# 44 | CAMELBACK

Planned Unit Development  
**Development Narrative**  
Case No. Z-36-A-19-6

## **PUD MAJOR AMENDMENTS**

### ***Major Amendment #1: September 25, 2020***

**EX 6C**  
SITE LIA & SITE  
COVERAGE PLANS

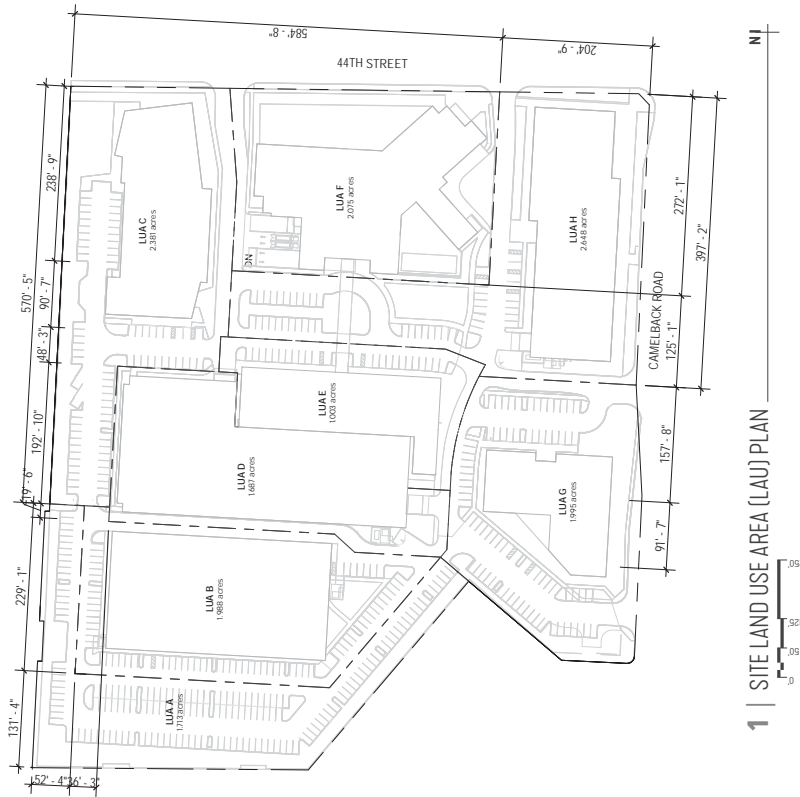
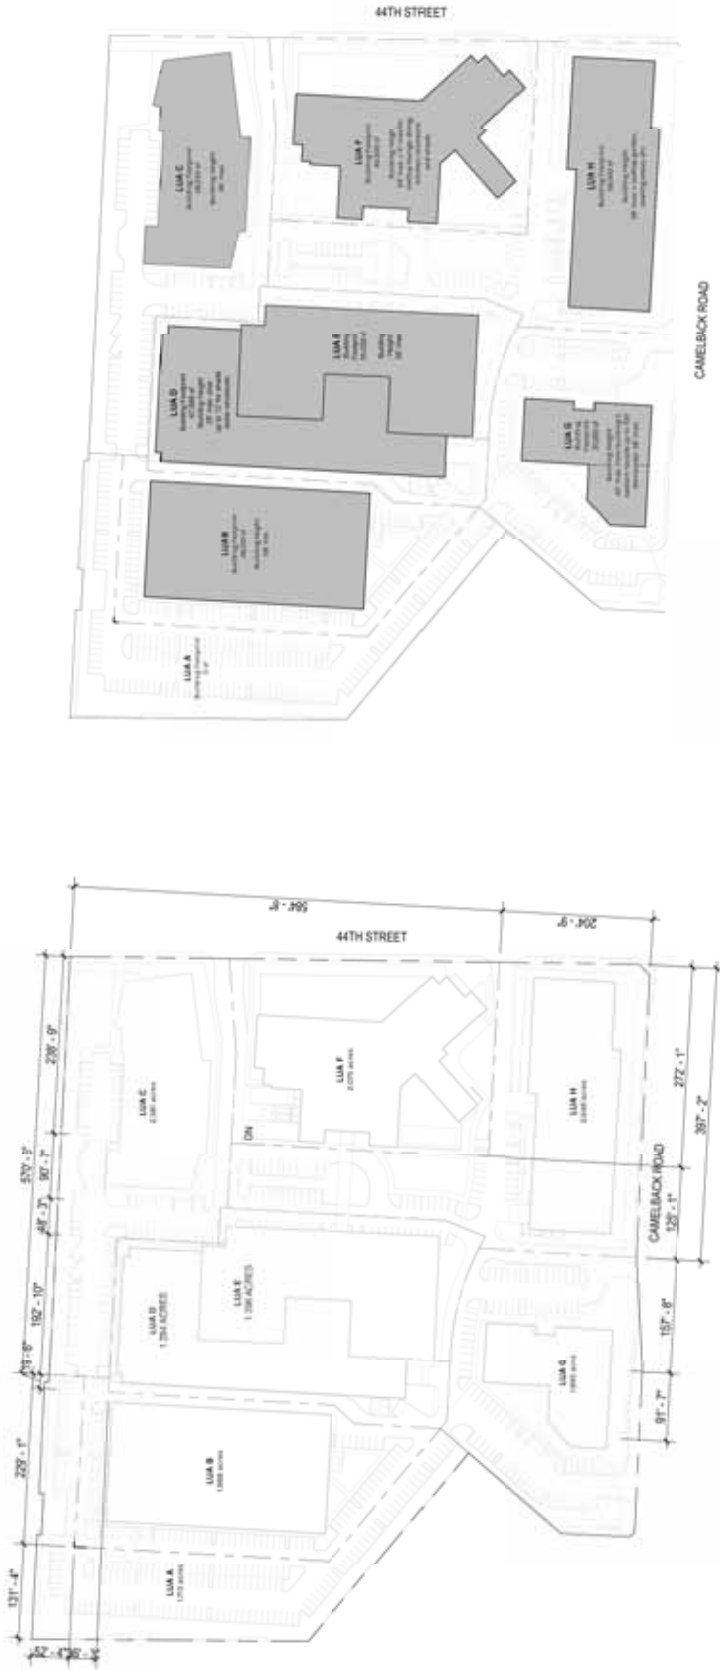
**Exhibit 6C: Site Land Use Area & Site Lot Coverage Plans.**

Added Alternative Plan for Multifamily and Retail development within LUA E.

**EX 7B**  
CONCEPTUAL SITE  
PLAN

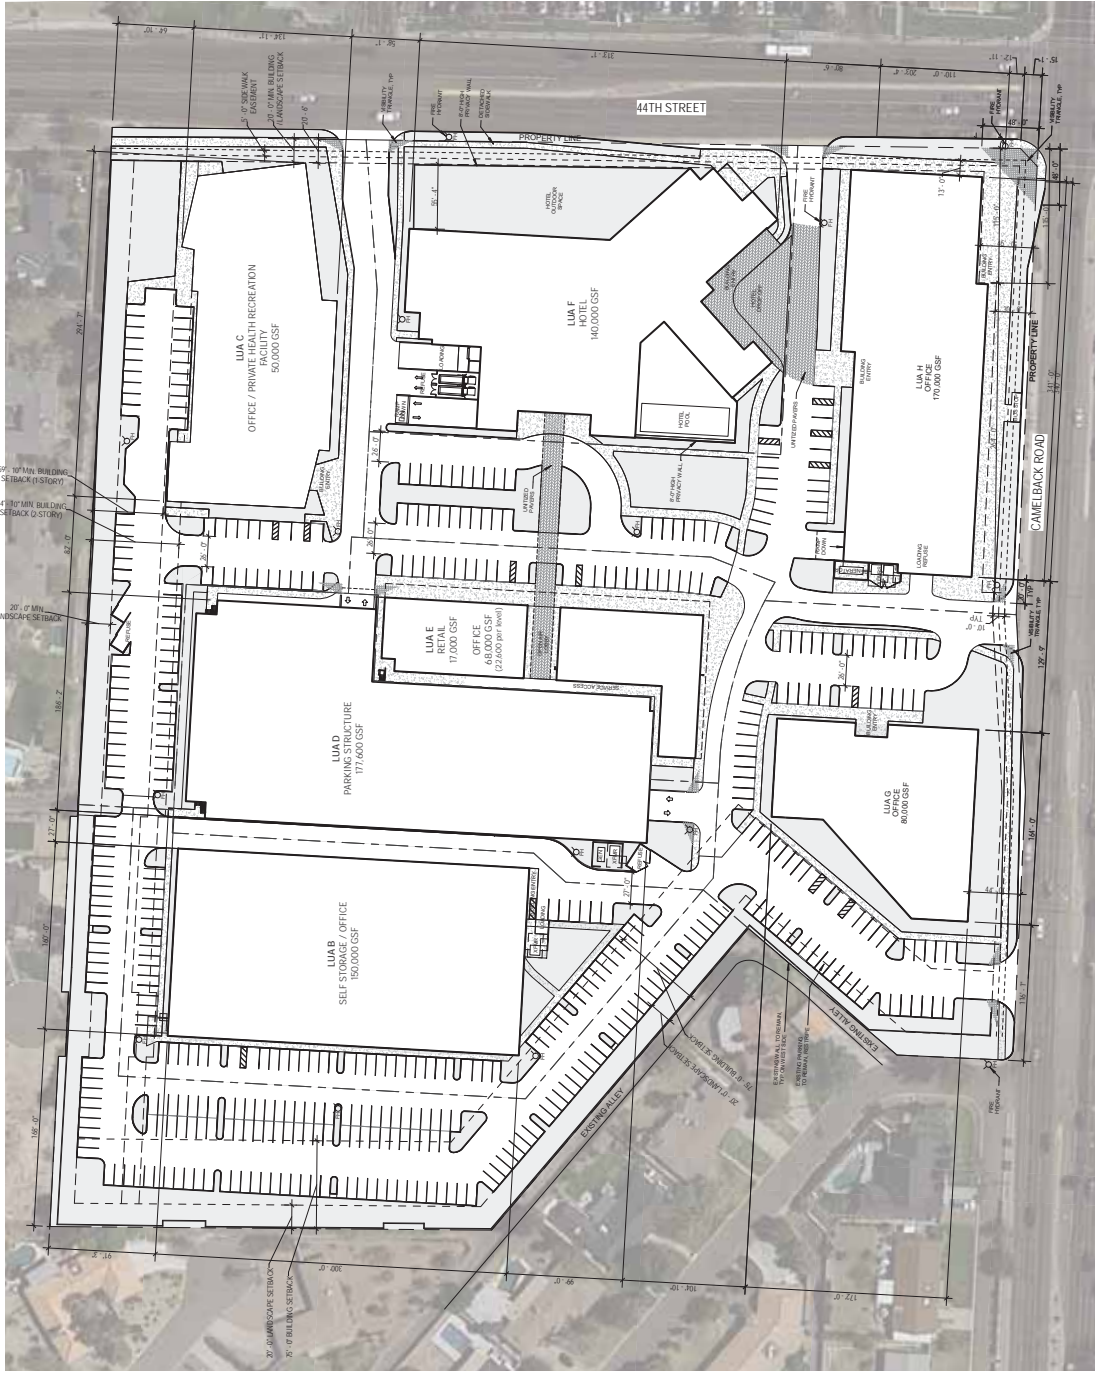
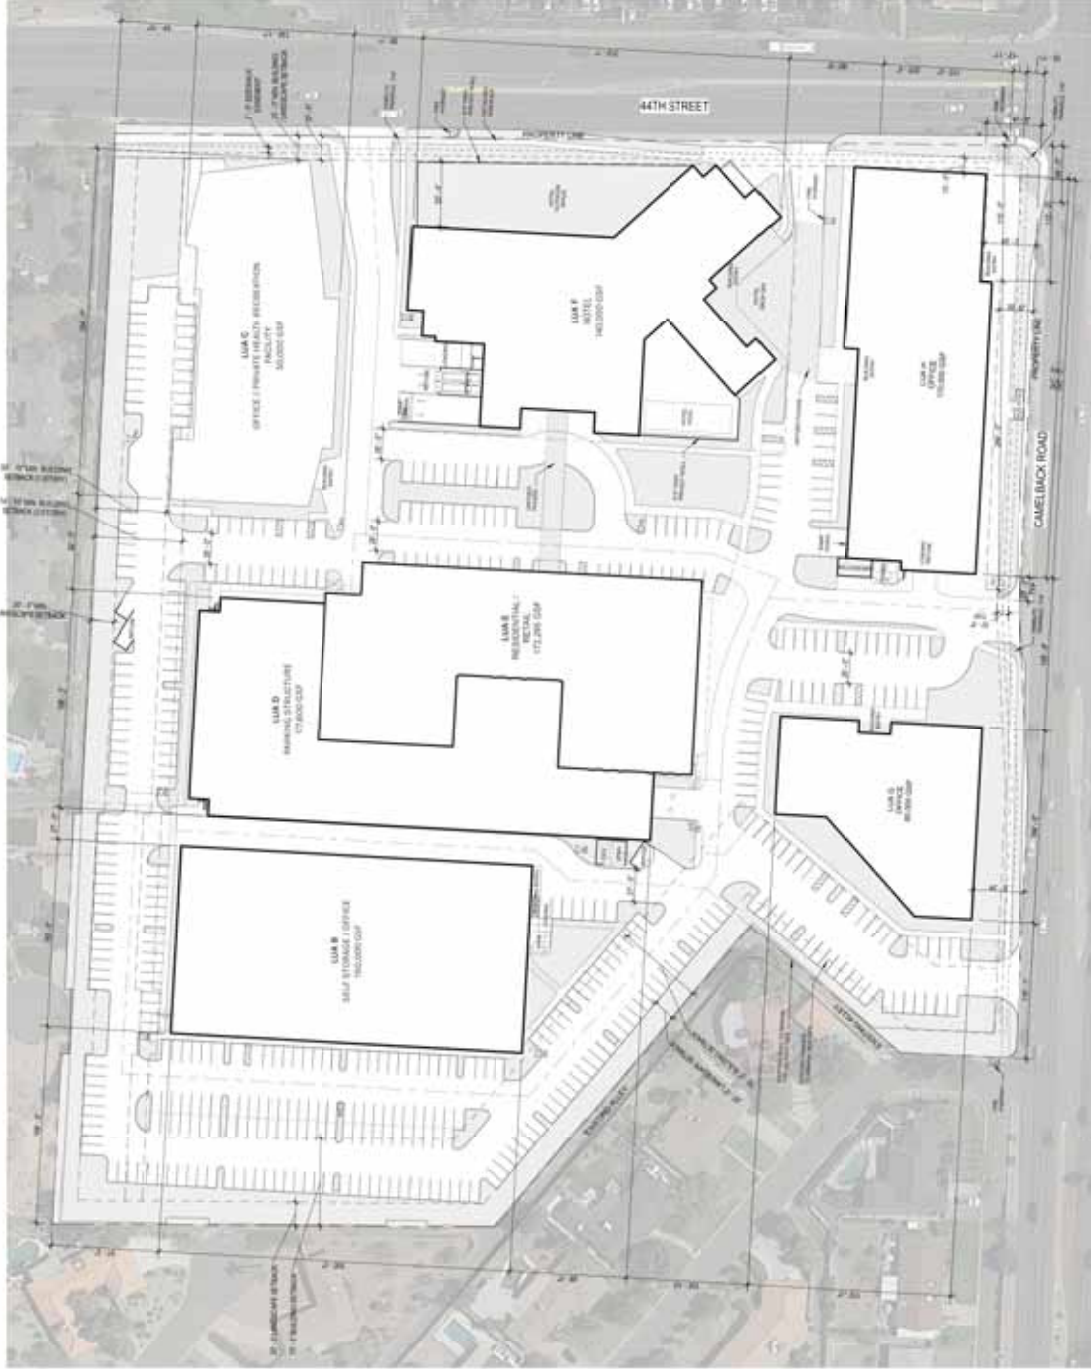
**Exhibit 7B: Conceptual Site Plan.**

Added Alternative Plan for Multifamily and Retail development within LUA E.

**EX 11**  
PROPOSED  
RESIDENTIAL HEIGHT  
STUDY

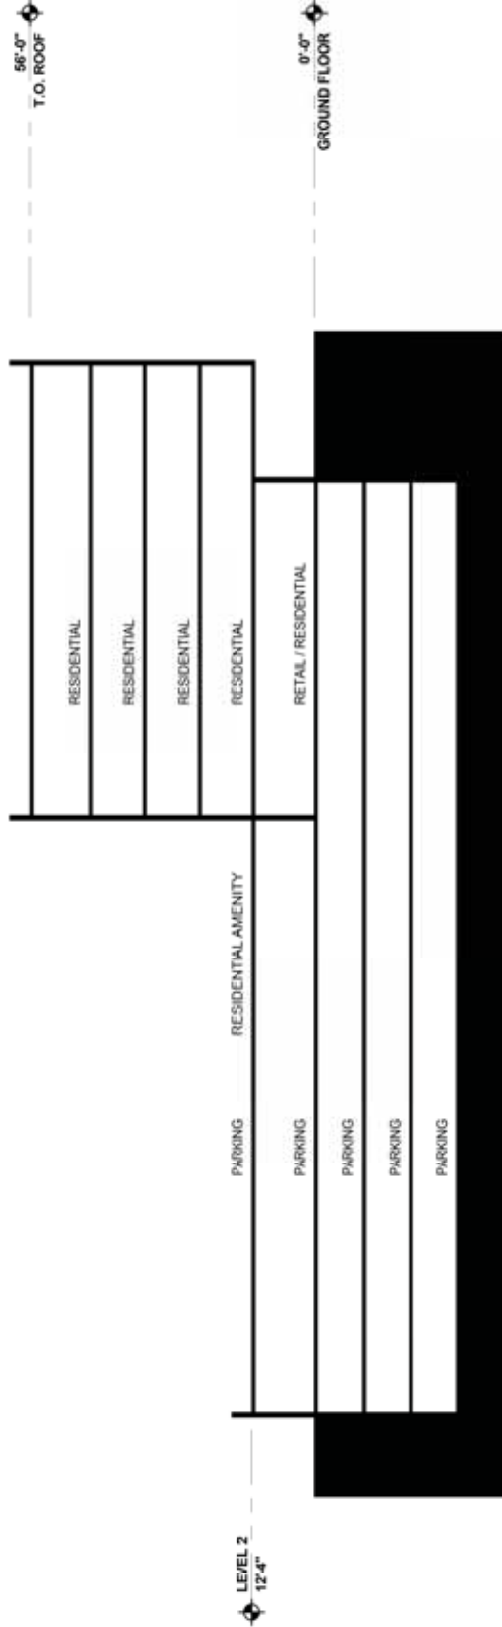
NOTE:  
THIS SECTION DIAGRAM IS AN ALTERNATIVE TO ORIGINAL  
OFFICE / RETAIL CONFIGURATION
